FACTORY SERVICE BULLETINS

These suggestions and solutions for technical problems come from service bulletins and other technical information published by Mercedes-Benz, selected and rewritten for independent repair shops.

Front Brake Squeal Models ML430, ML500 and ML55 AMG

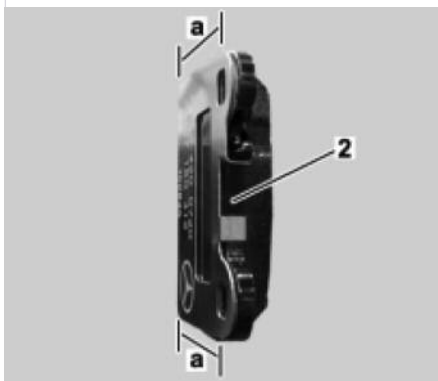
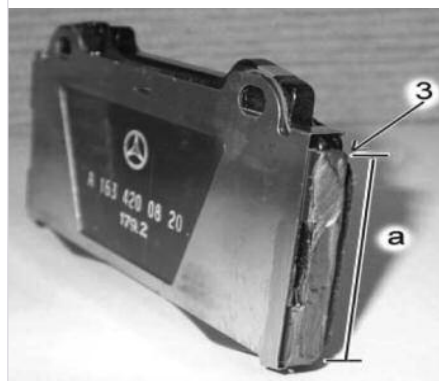
Although squealing brakes are not the problem they once were, the condition still shows up from time to time. It may be aggravated by cool, damp weather in combination with light braking effort. Besides switching to improved friction material, it's been found that

the judicious application of brake paste to the ends of the pad backing plates as shown can reduce the noise. If you receive customer reports in the above model vehicles of brake squeal emanating from the front of the vehicle, please order the improved brake pads available from your local M-B dealer's parts department, and perform the following procedure:

2. Apply brake pad paste to the ends of the replacement brake pads' backing plates as shown. Reference WIS document AR42.10-P-0161-01GH

Note: Do not allow any paste to contact brake pad friction surface or apply paste to any other areas besides those specified. Immediately remove any excess paste that contacts pad front or
